HP PERMIT NUMBER: HP-0817-2026

PROPERTY ADDRESS: 1583 Swan Drive

A. CASE ITEMS FOR CONSIDERATION

HP PERMIT NUMBER: HP-0823-2026

Applicants proposed options

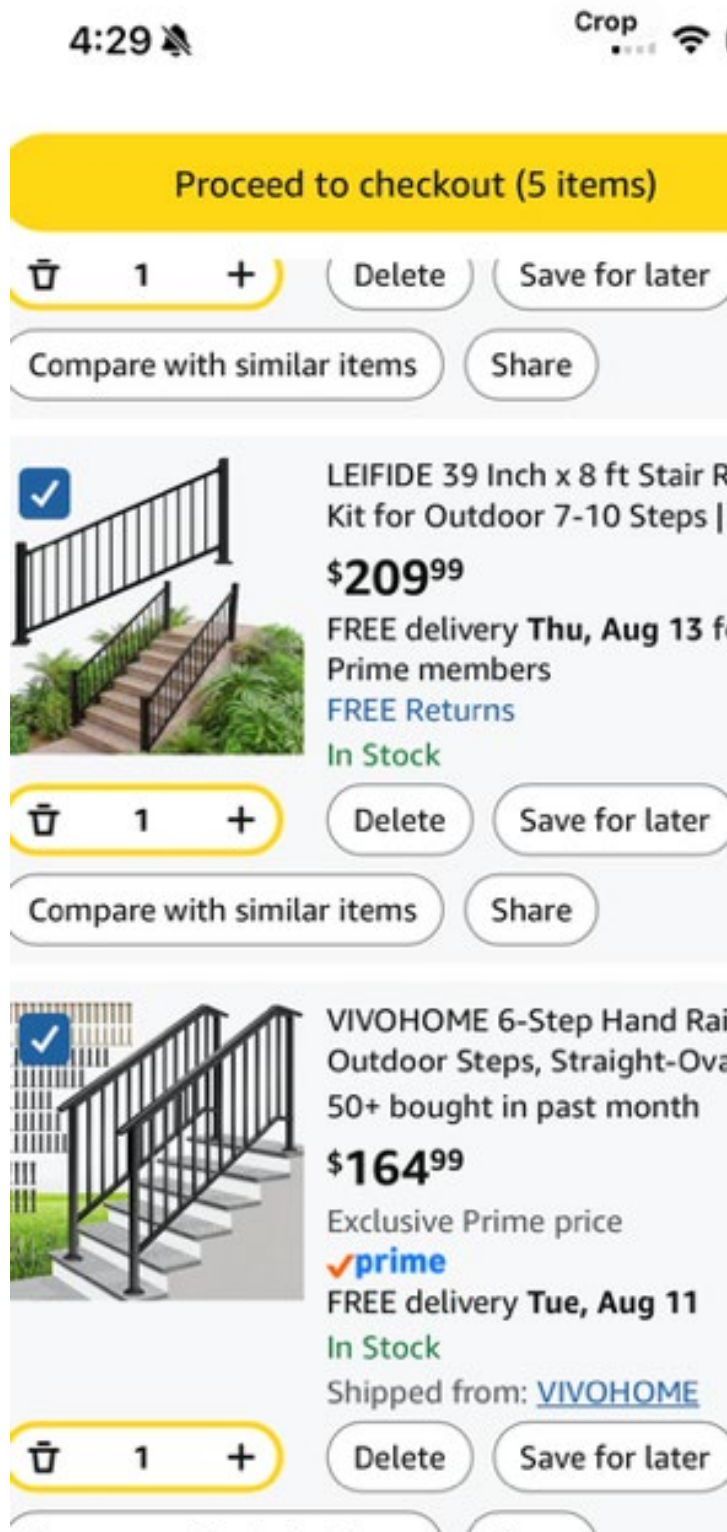
1. The applicant proposes to install a handrail on each side of the existing concrete steps located at the edge of the property along the street.

During review on September 10, 2026 the Historic Preservation Permit Subcommittee recommended the denial of the proposal as submitted. It was recommended that the applicant explore a single, center aligned railing instead of a railing on each side. It was also recommended that the railing be more heavy duty and be without exposed assembly screws.

Photo provided by applicant

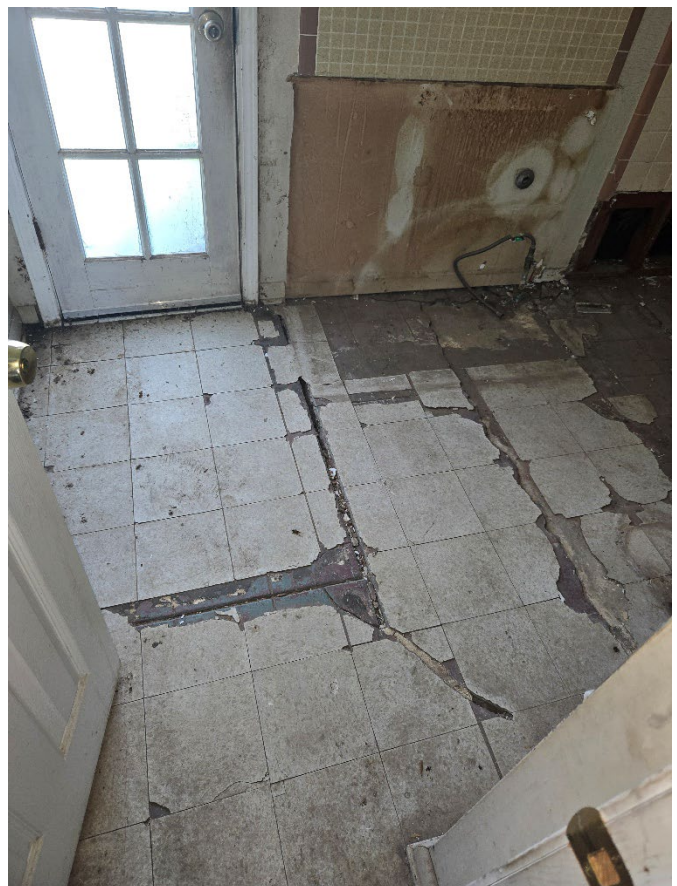
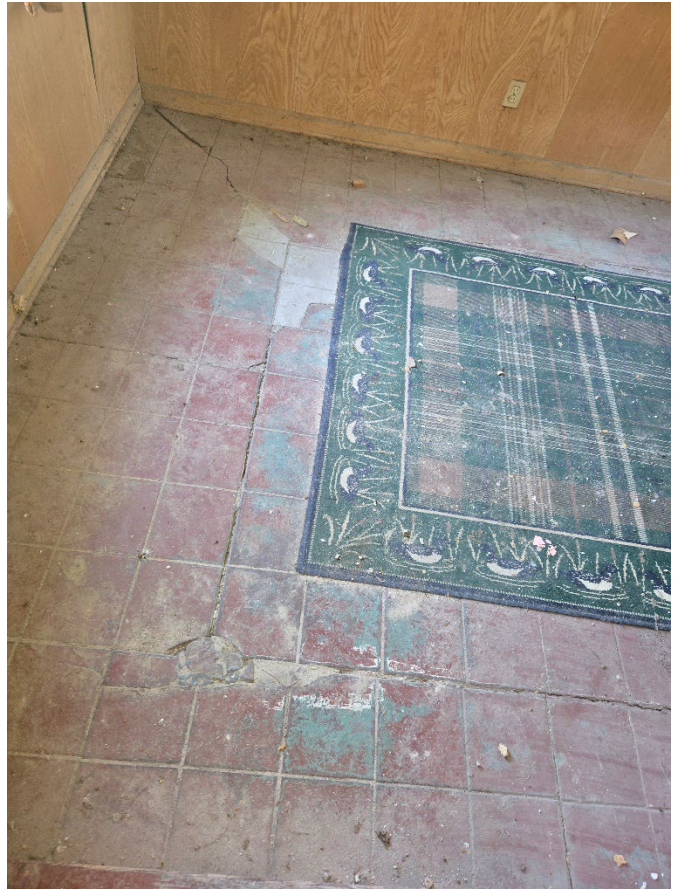
1. The demolition of the residence is requested. Applicant claims that the structure has deteriorated significantly.

During the Historic Preservation Permit Subcommittee review on August 27, 2026, the committee reviewed the application and the documentation regarding the structural integrity of the home and the financial constraints of the owner related to rehabilitating the property in its current state. The subcommittee recommended approval, citing guideline F 1.1.

BASEMENT PLAN

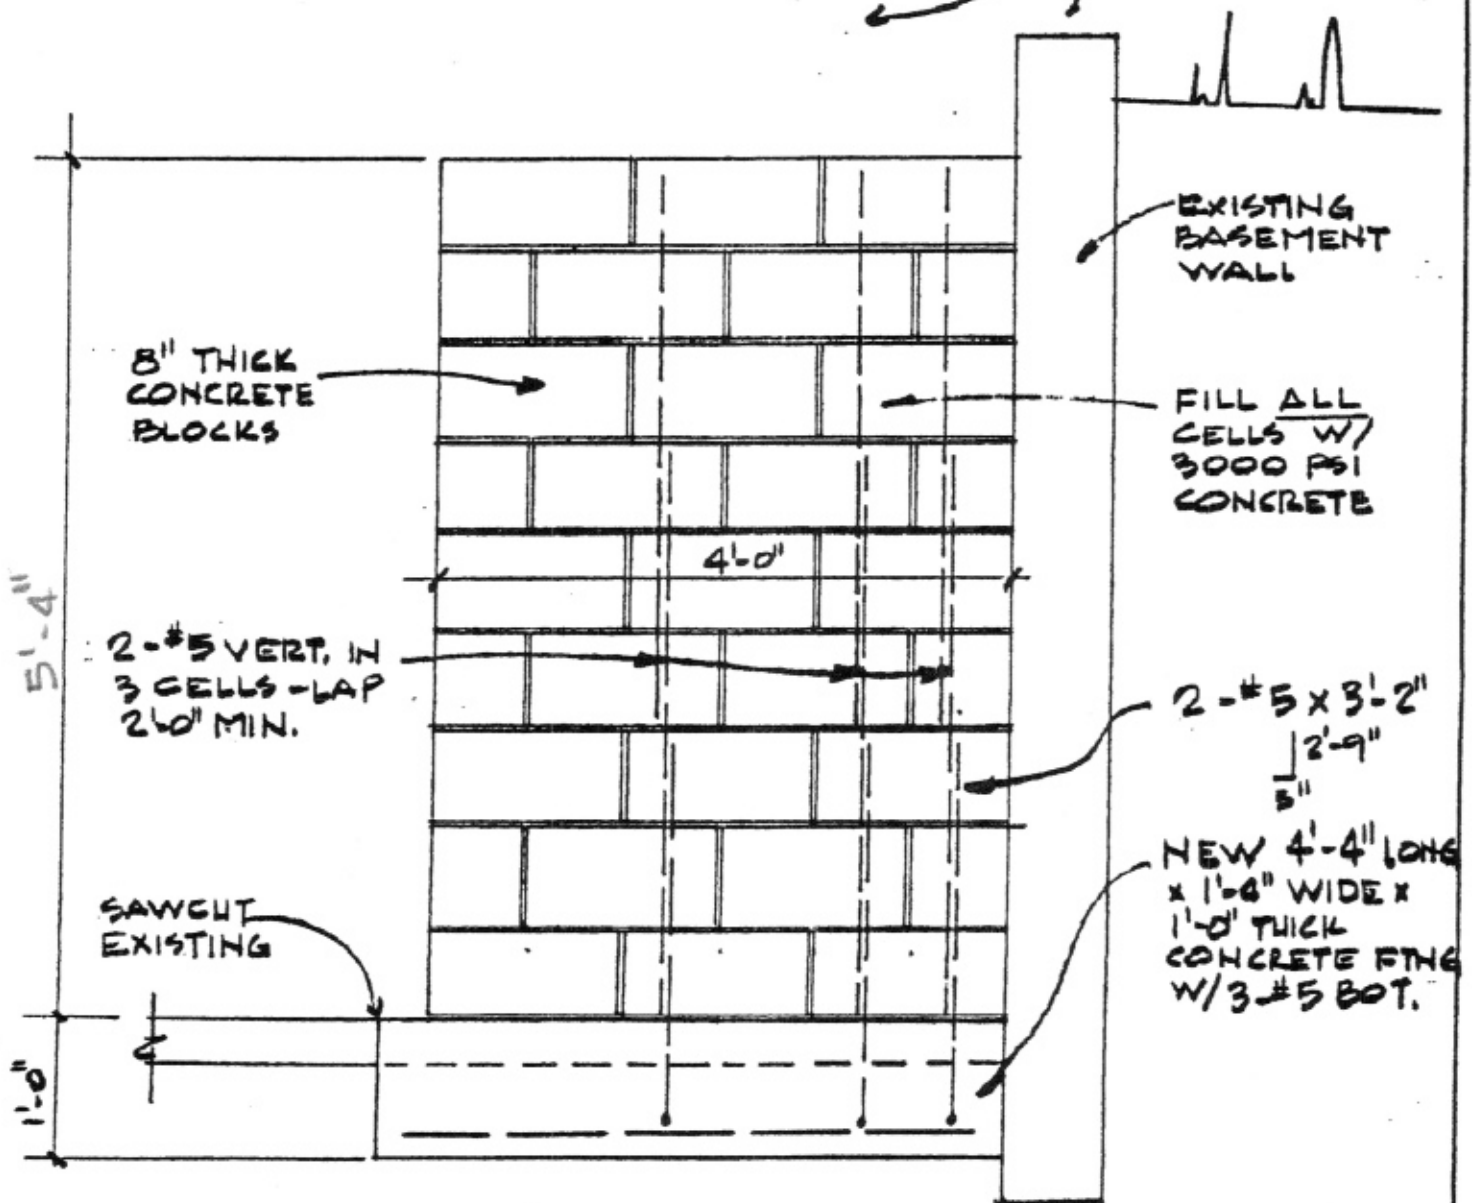
It is recommended that new concrete block shear walls be installed to stabilize portions of the perimeter basement walls against additional inward displacement. A basement plan and a typical Shear Wall Detail have been enclosed to provide the locations and the construction information for these shear walls. Please note that the shear walls will not straighten or re-align the existing walls. Their purpose is to resist soil forces and prevent additional wall displacement.

SHEAR WALL DETAIL

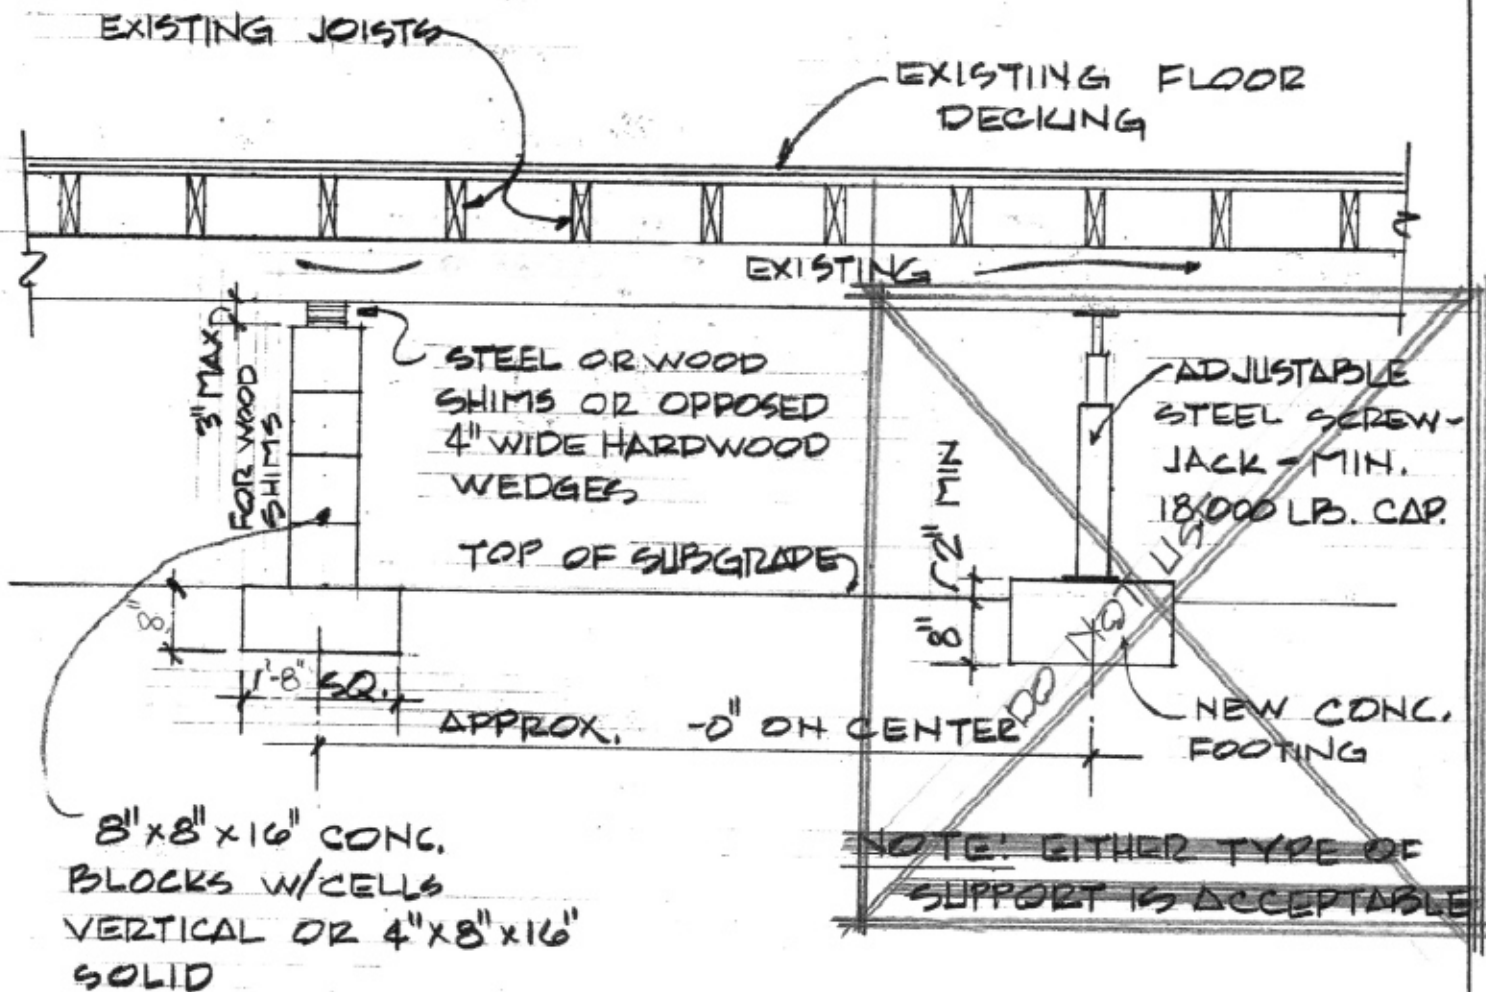
It is recommended that a new poured-in-place concrete footing and concrete block support be installed beneath the framing under the north jamb of the doorway between the front entry area and the northwest dining room. A Typical Interior Floor Support Detail has been included to provide the criteria for that support. Please note that use of a precast concrete pad for the footing is specifically NOT recommended. Installation of supplemental miscellaneous framing in this area will also be necessary.

Newly installed 4-inch by 4-inch porch columns (picture provided by the applicant)

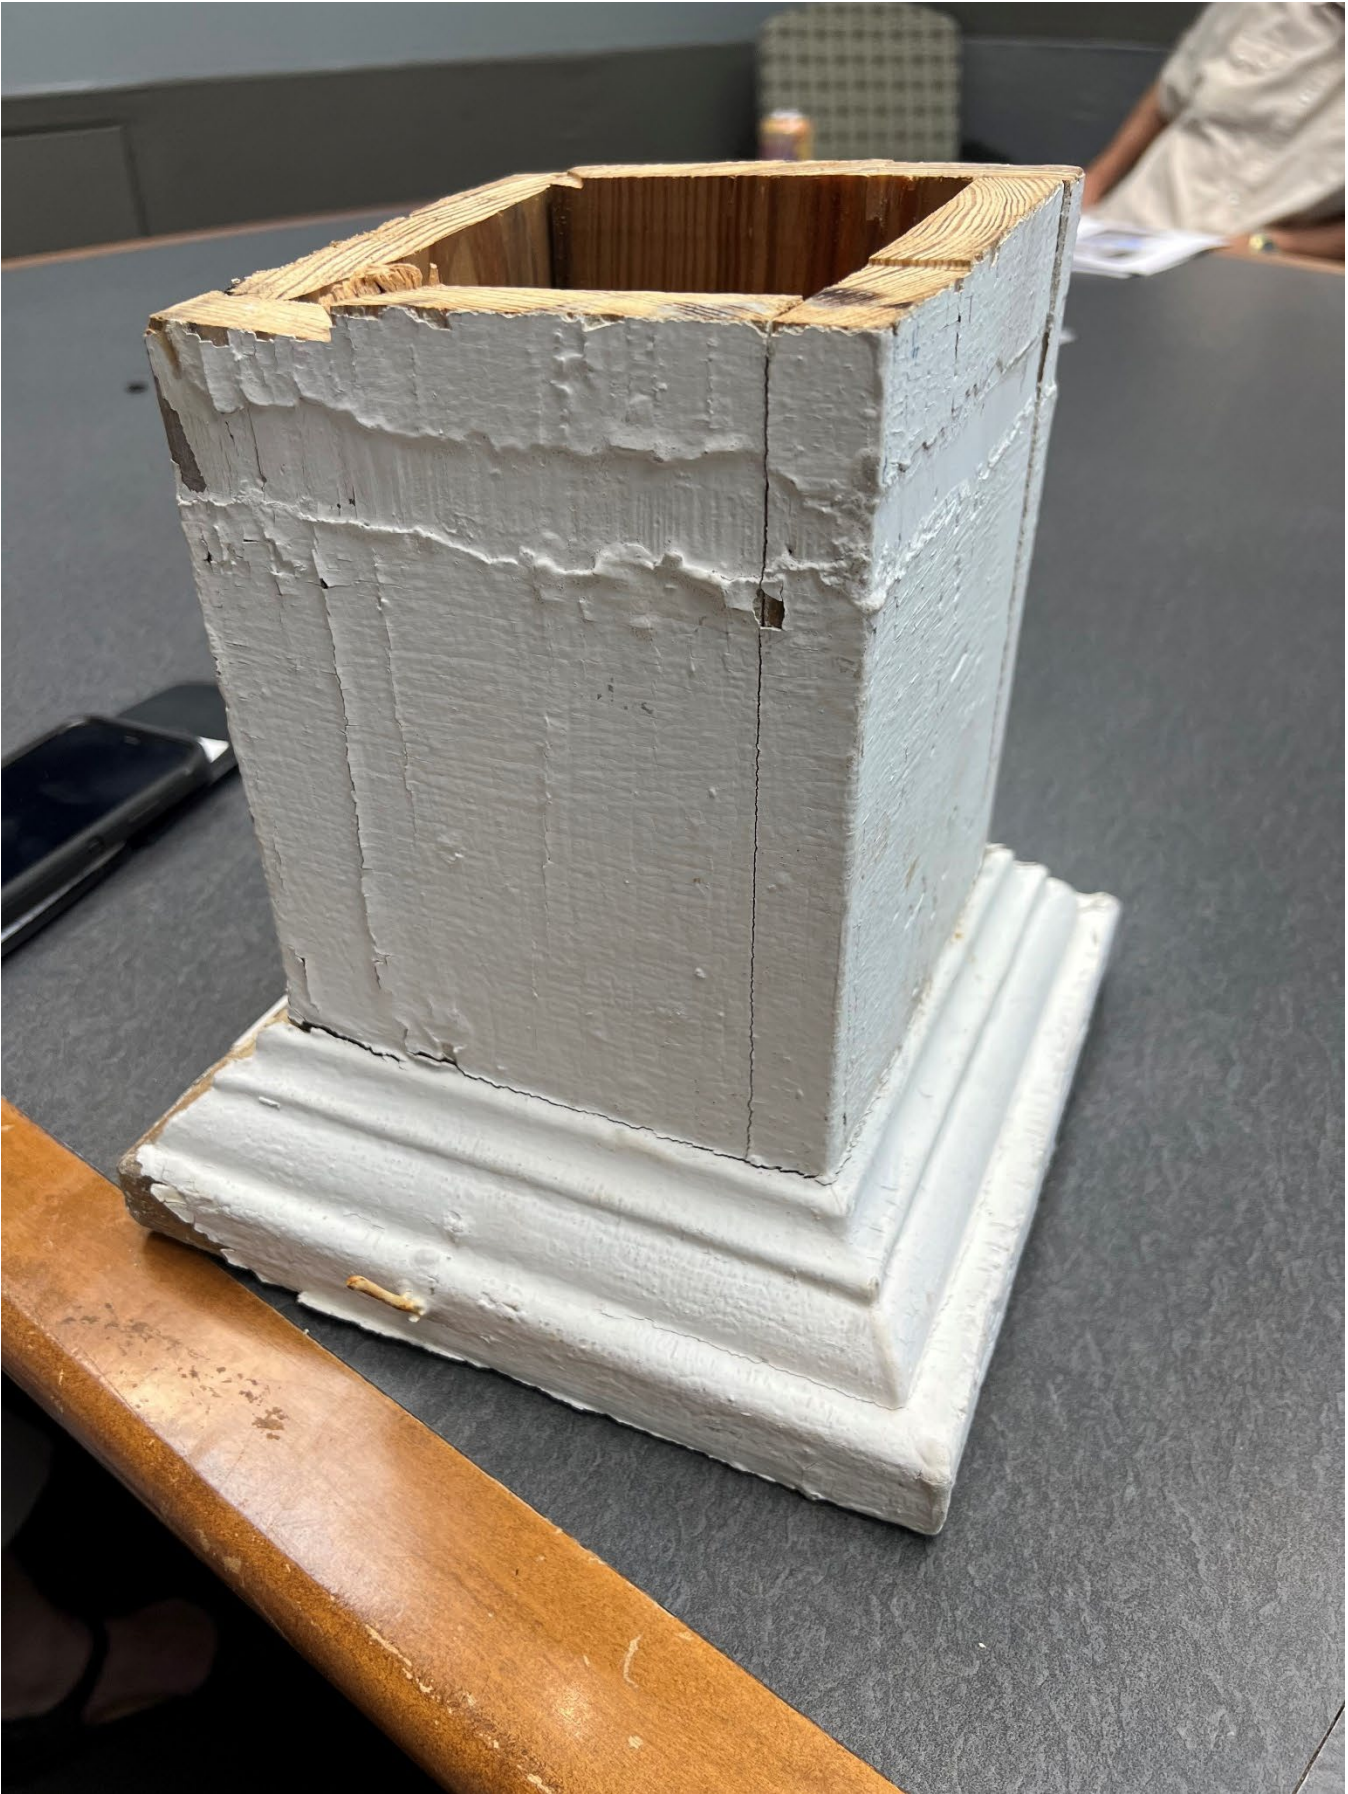
- A.6.1 Retain and preserve the original historic porch and its character-defining architectural features through repair.
- A.6.2 Do not remove character-defining architectural features of your porch, including, but not limited to, ceiling, floor, piers, columns, railings, handrails, steps, bulkheads, skirt/stem wall, and decorative details, such as crown molding, trim, eave brackets, and exposed rafter tails.
